MARK	DESCRIPTION	DATE	APPR.
1	REV IN ACCORDANCE WITH AMDT 0004	DEC 2017

HURRICANE & STORM DAMAGE REDUCTION
RARITAN BAY & SANDY HOOK BAY
PHASE II, CONTRACT 4
FORT MONMOUTH, NJ

FLOODWALL PLAN OVERVIEW PART 2

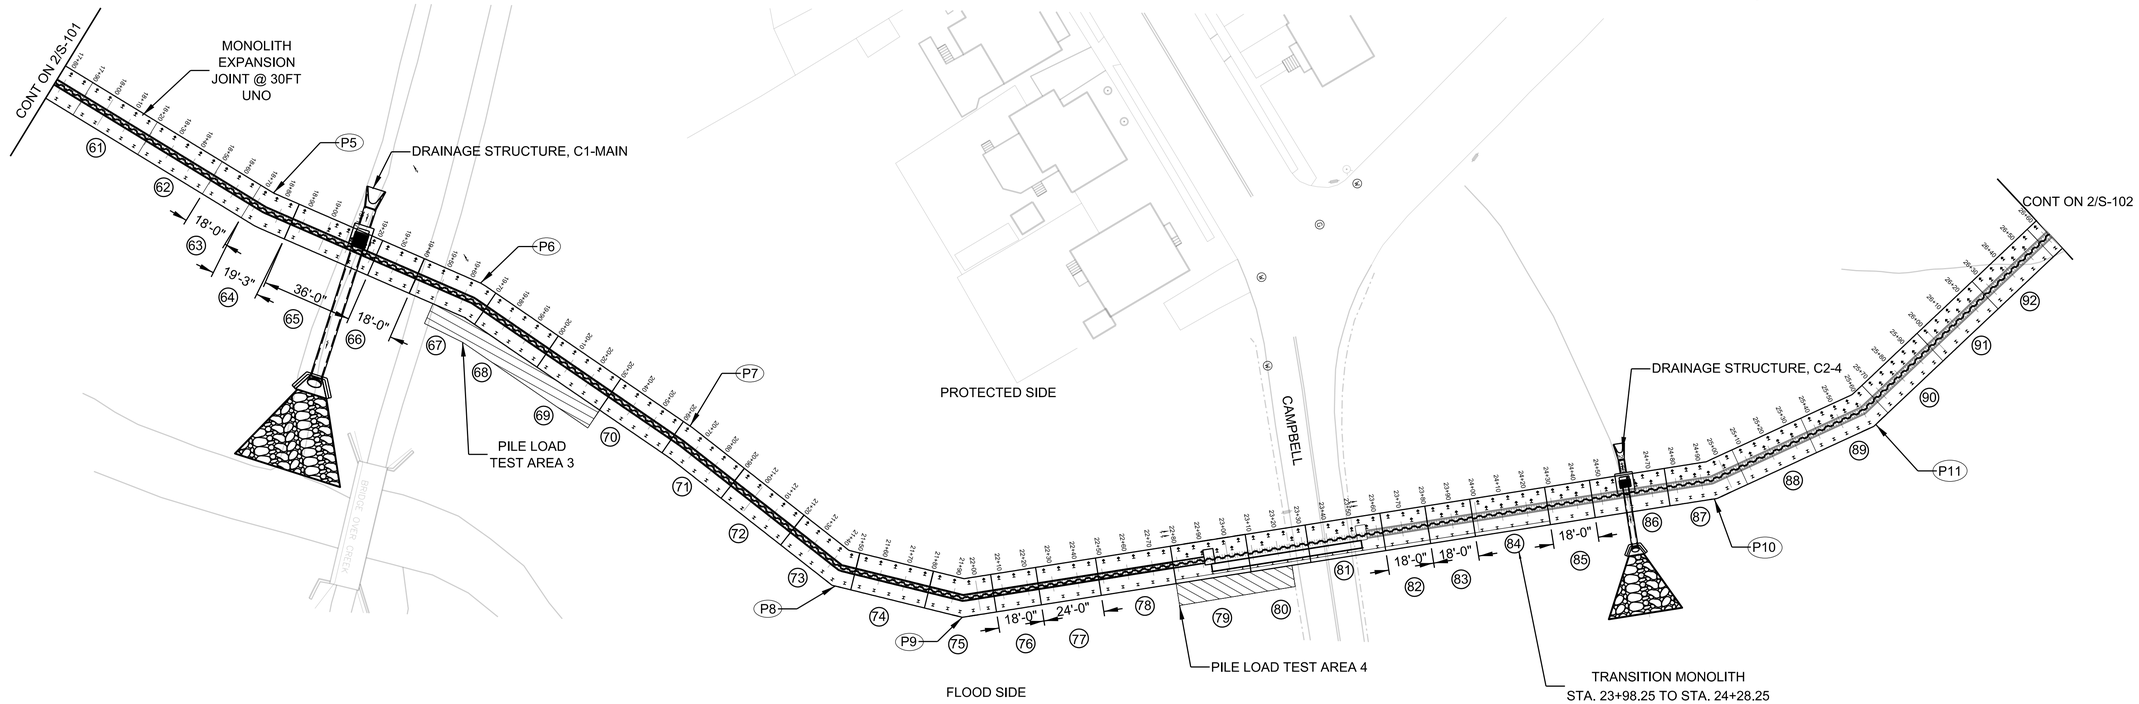
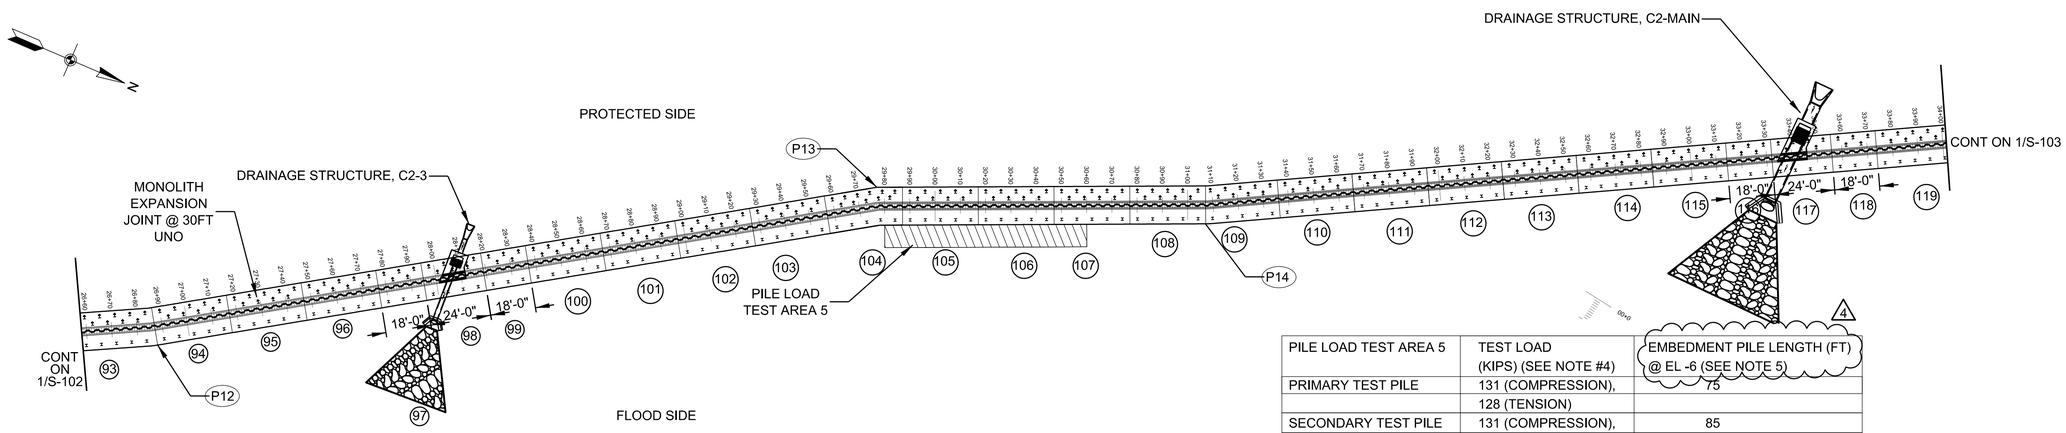
MARK	DESCRIPTION	DATE	APPR.	MARK	DESCRIPTION	DATE	APPR.
4	PILE LENGTH NOTE ADDED	DEC-2017

NOTES:
1. BEND POINT DENOTED AS P# AND MONOLITH NUMBER DENOTED AS #
2. BEND MONOLITHS ARE SHOWN ON SHEETS S-105 AND S-106
3. SHEET PILE CUT-OFF WALL IS AT CENTERLINE OF FLOODWALL STEM UNLESS NOTED OTHERWISE.
4. TEST PILE SHALL BE LOADED TO A MAXIMUM OF 300% OF THE TEST LOAD SHOWN HERE PER SPEC 31 62 16.16
5. CONTRACTOR SHALL ADD ADDITIONAL LENGTH TO THE TEST PILE LENGTH TO ACCOUNT FOR THE DIFFERENCE BETWEEN THE SOIL ELEVATIONS AT THE TEST LOCATIONS AND THE BOTTOM OF THE FLOODWALL. THE CONTRACTOR SHALL INSTALL A CASING AROUND THE PILE FOR THE ADDITIONAL LENGTH AND SHALL REMOVE THE SOIL BETWEEN THE CASING AND THE PILE FOR THIS ADDITIONAL LENGTH. 4

FLOODWALL PLAN
OVERVIEW PART 3

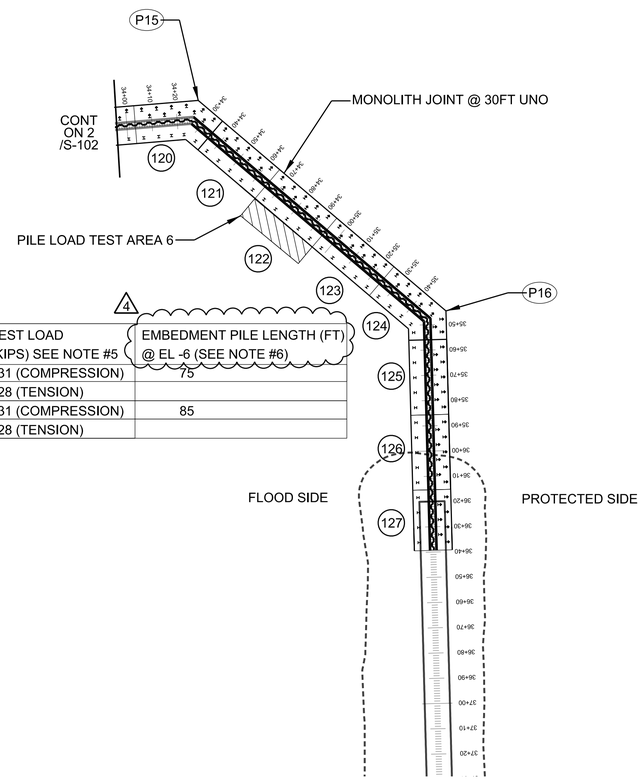
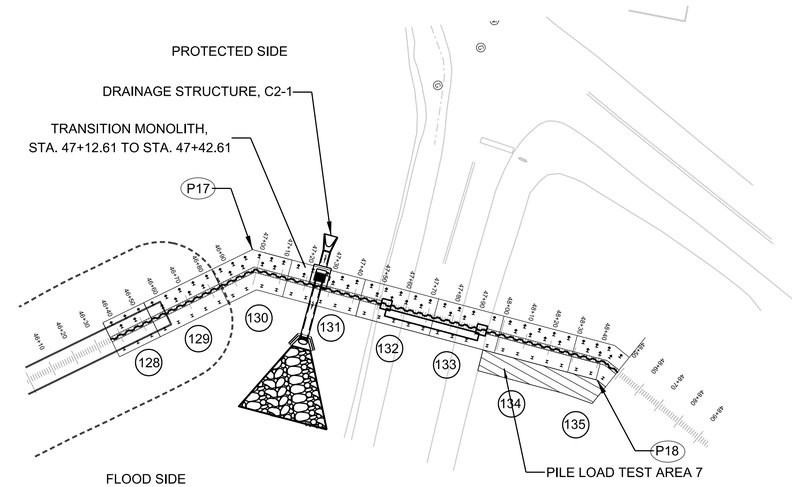
MARK	DESCRIPTION	DATE	APPR.	MARK	DESCRIPTION	DATE	APPR.
4	PILE LENGTH NOTE ADDED	DEC 2017

1. LEVEE TO FLOODWALL TRANSITION DETAIL ON SHEET S-104
2. BEND POINT DENOTED AS P# AND MONOLITH NUMBER DENOTED AS #
3. BEND MONOLITHS ARE SHOWN ON SHEETS S-105 AND S-106
4. SHEET PILE CUT-OFF WALL IS AT CENTERLINE OF FLOODWALL STEM UNLESS NOTED OTHERWISE.
5. TEST PILE SHALL BE LOADED TO A MAXIMUM OF 300% OF THE TEST LOAD SHOWN HERE PER SPEC 31 62 16.16
6. CONTRACTOR SHALL ADD ADDITIONAL LENGTH TO THE TEST PILE LENGTH TO ACCOUNT FOR THE DIFFERENCE BETWEEN THE SOIL ELEVATIONS AT THE TEST LOCATIONS AND THE BOTTOM OF THE FLOODWALL. THE CONTRACTOR SHALL INSTALL A CASING AROUND THE PILE FOR THE ADDITIONAL LENGTH AND SHALL REMOVE THE SOIL BETWEEN THE CASING AND THE PILE FOR THIS ADDITIONAL LENGTH.

CAMPBELL CLOSURE GATE FOUNDATION PLAN AND SCHEMATIC

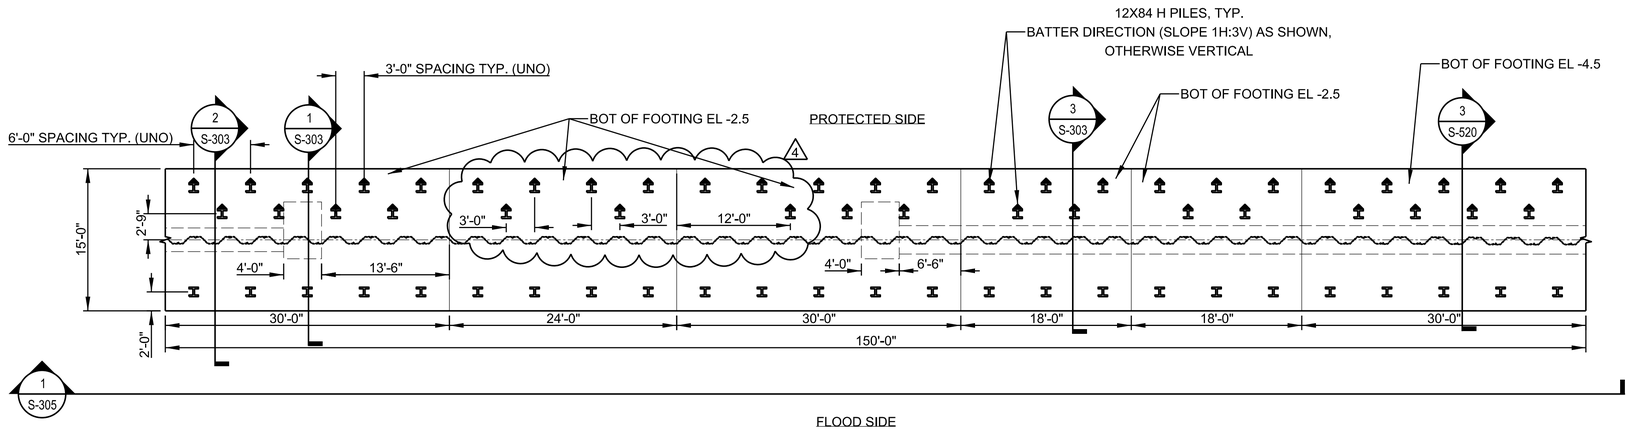
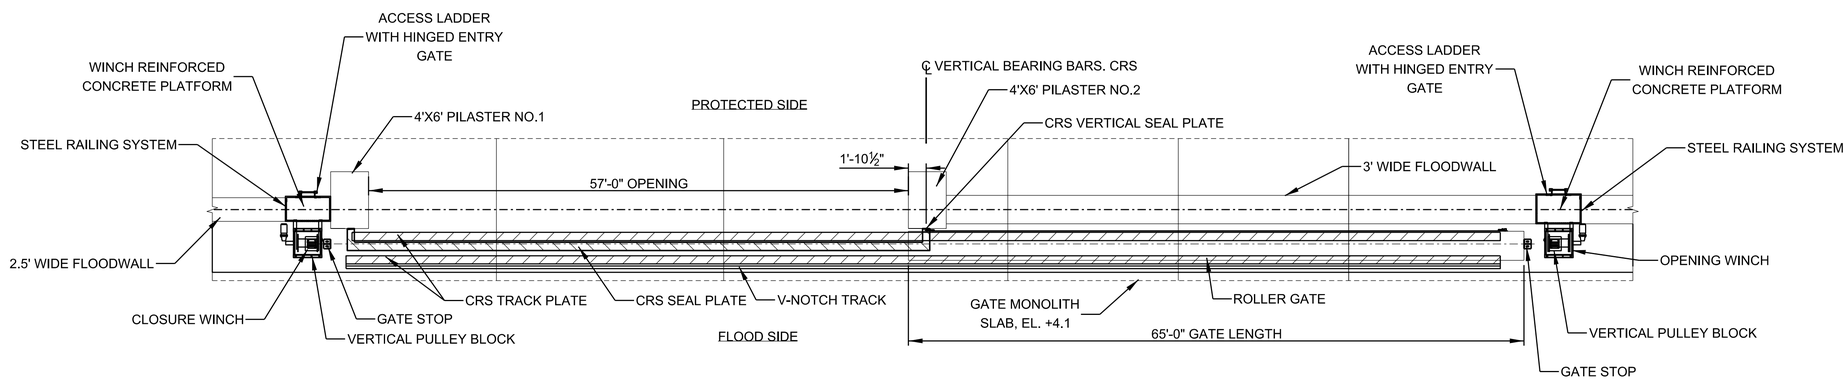
MARK	DESCRIPTION	DATE	APPR.	MARK	DESCRIPTION	DATE	APPR.
1	PILE AND DIMENSION SPACE CHANGED	DEC-2017

BROADWAY CLOSURE GATE
FOUNDATION PLAN
AND SCHEMATIC

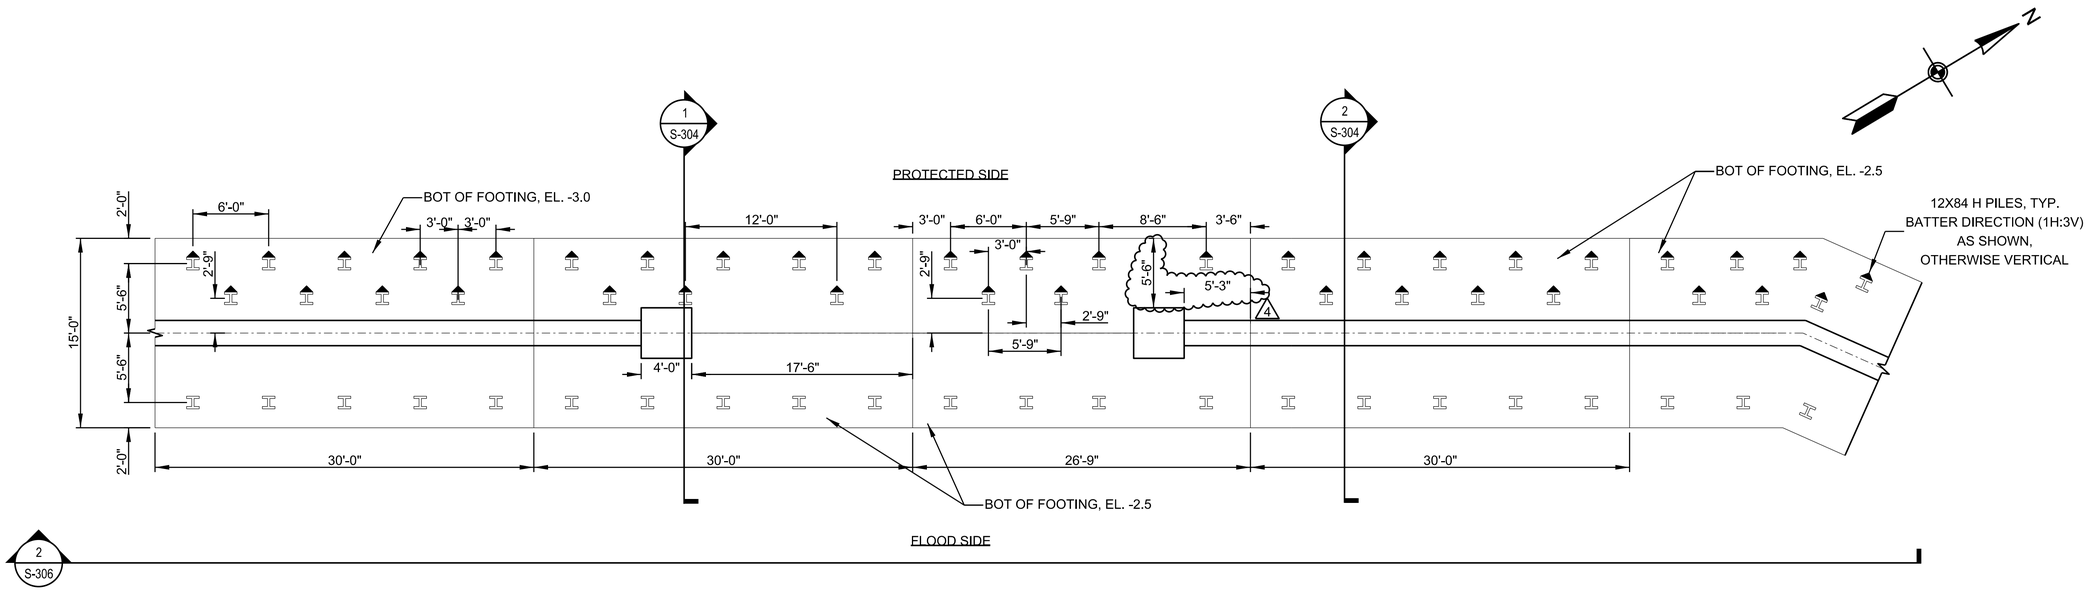
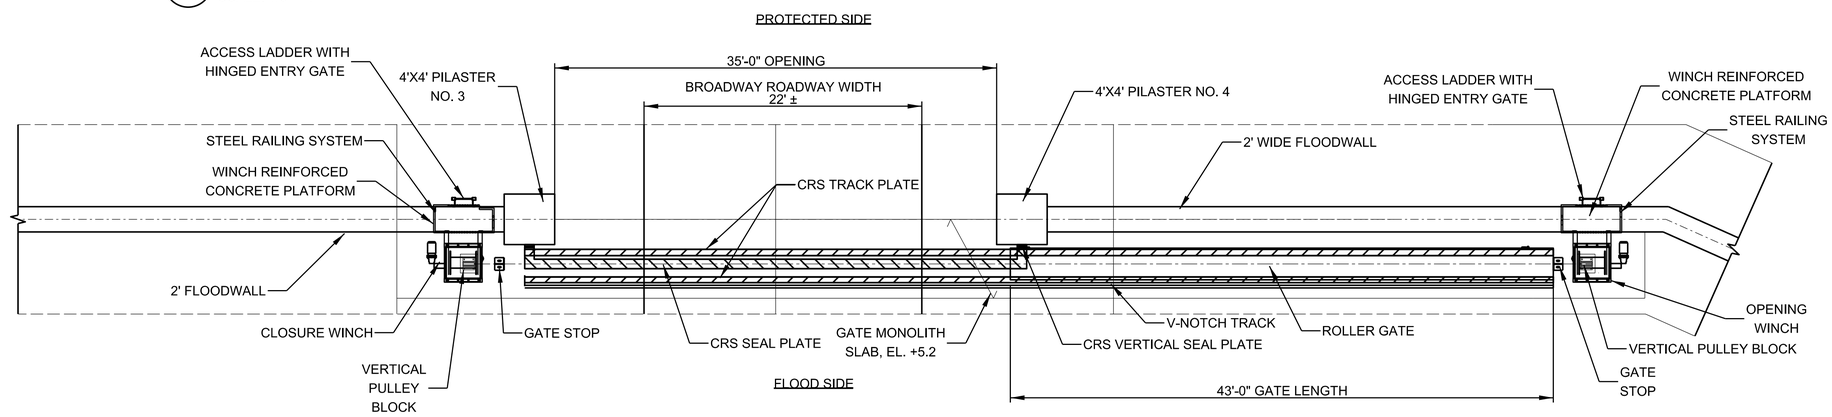
MARK	DESCRIPTION	DATE	APPR.	MARK	DESCRIPTION	DATE	APPR.
1	DETAILS CHANGED	DEC 2017

4 S-301 FIXED PILE CONNECTIONS
SCALE: NTS

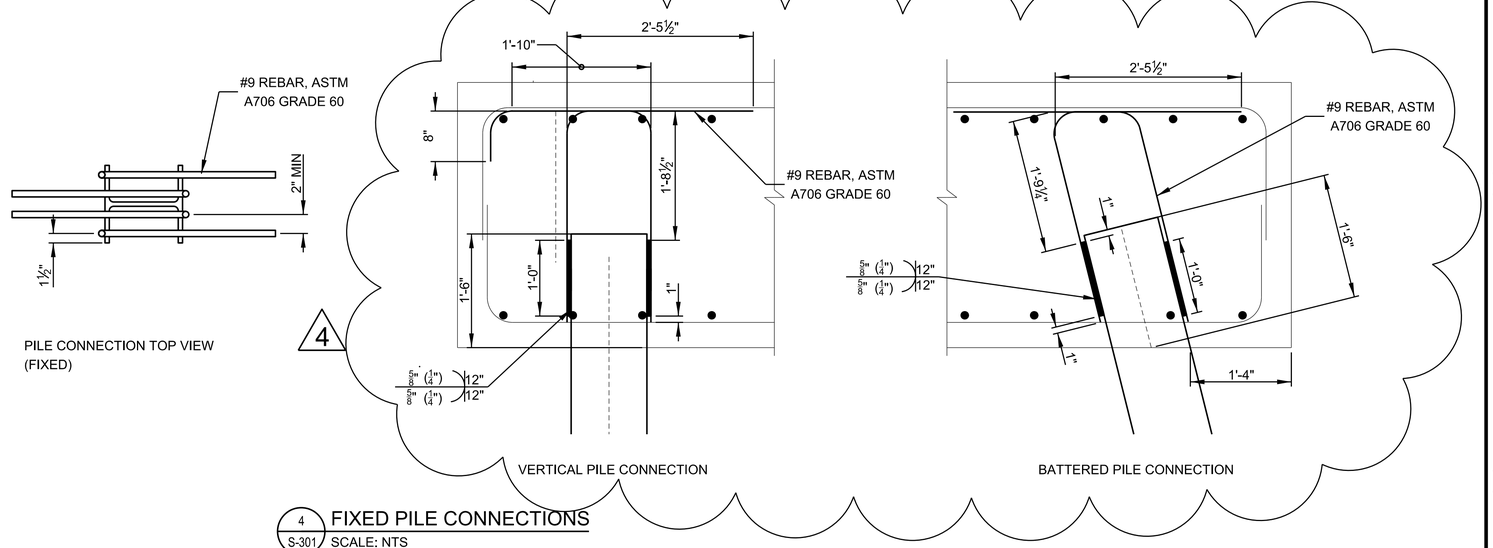
MARK	DESCRIPTION	DATE	APPR.	MARK	DESCRIPTION	DATE	APPR.
4	PILE CONNECTION DETAIL CHANGED	DEC 2017

5 S-302 PINNED PILE CONNECTIONS
SCALE: NTS

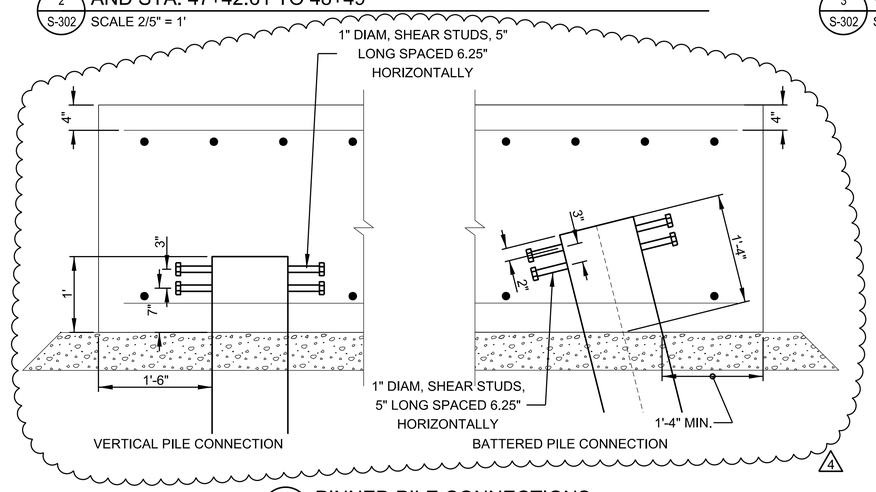
MARK	DESCRIPTION	DATE	APPR.	MARK	DESCRIPTION	DATE	APPR.
1	PINNED CONNECTION DETAIL UPDATED	DEC 2017

8 S-307 TYPICAL GAS PIPE THRU STEEL SHEET PILING
NTS

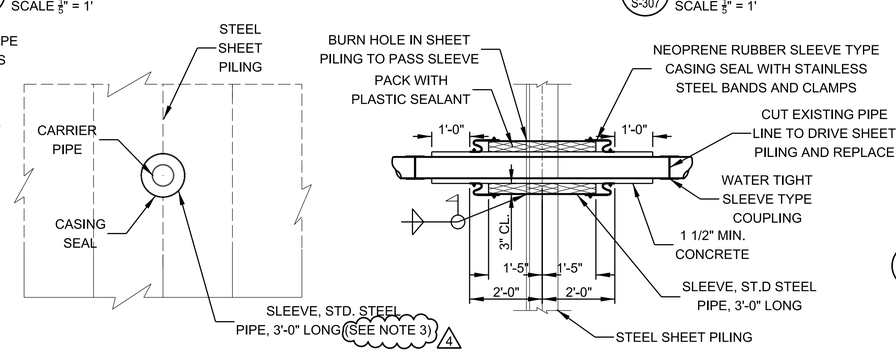
MARK	DESCRIPTION	DATE	APPR.
4	NOTES UPDATED	2 NOV 2017

NOTES:
1. REFER TO CIVIL DRAWINGS FOR PIPE DETAILS
2. PILES LENGTH ARE NOT SHOWN TO SCALE.
3. CONTRACTOR SHALL SUPPLY AND INSTALL SLEEVES ONLY PER REQUIREMENTS ON SHEET S-311. NJNG TO SUPPLY AND INSTALL ALL GAS MAIN AND ASSOCIATED INTERNAL CASING COMPONENTS.

FLOODWALL SECTIONS FOR GAS AND WATER PIPES

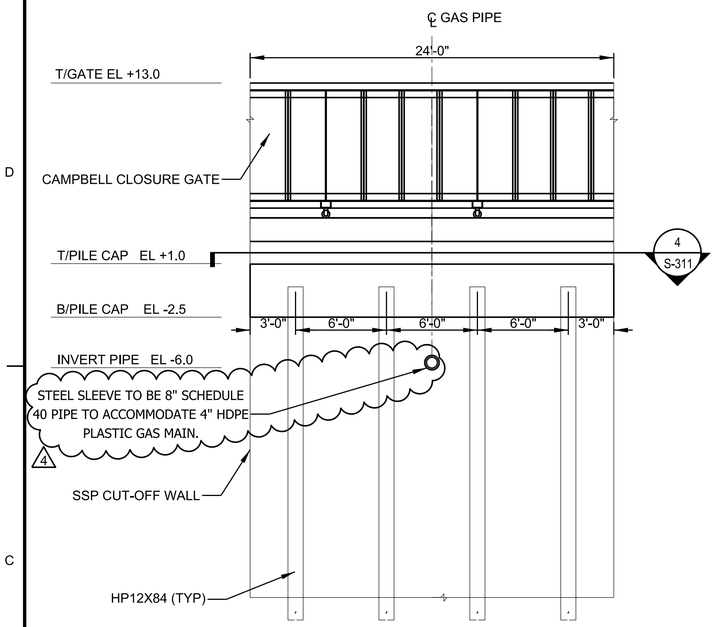
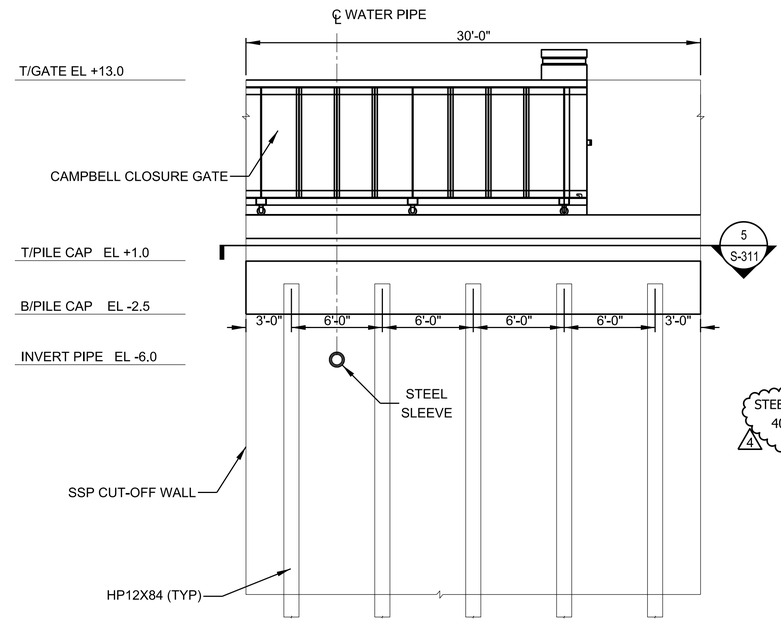
MARK	DESCRIPTION	DATE	APPR.	MARK	DESCRIPTION	DATE	APPR.
1	revised STA for sections 1 + 2	24 AUG 2017					
2	STEEL SLEEVE NOTE UPDATED	2 NOV 2017

CLOSURE GATE DETAILS
PART 1

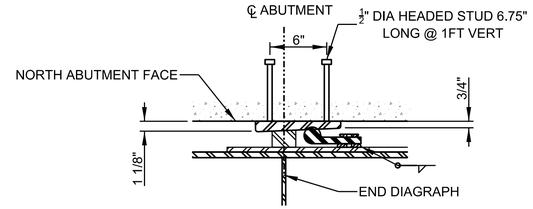
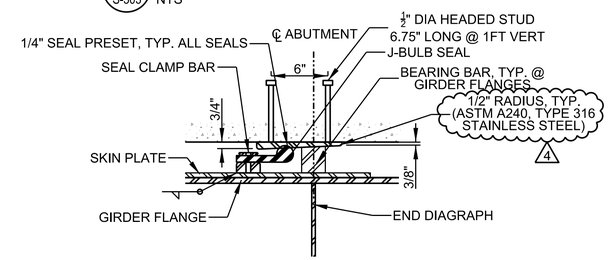
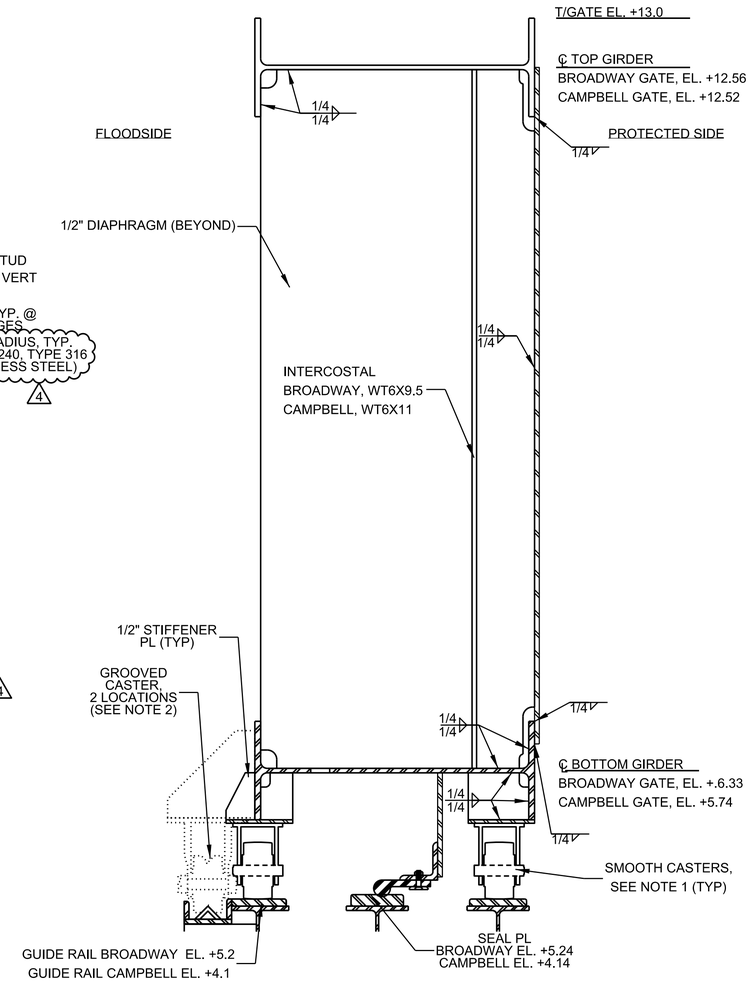
MATERIAL CHANGE AND NOTE ADDED DEC-2017

NOTES:
1.FINISH SEAL PLATES TO 125 MICROINCHES
2. SEAL BAR TO BE ASTM A240, TYPE 316 STAINLESS STEEL
3. HEADED STUDS TO BE ASTM A709. WELD PER AWS D1.6
4

3 S-504 SEAL DEFLECTION BAR (SOUTH ABUTMENT)
NTS

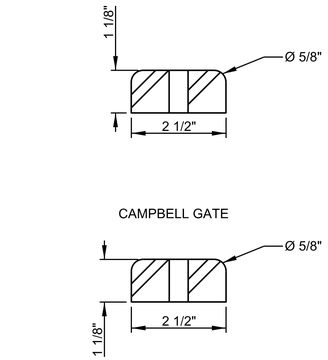
MARK	DESCRIPTION	DATE	APPR.	MARK	DESCRIPTION	DATE	APPR.
1	MATERIAL NOTE ADDED	DEC 2017

NOTE:
DEFLECTION BAR TO BE ASTM A709
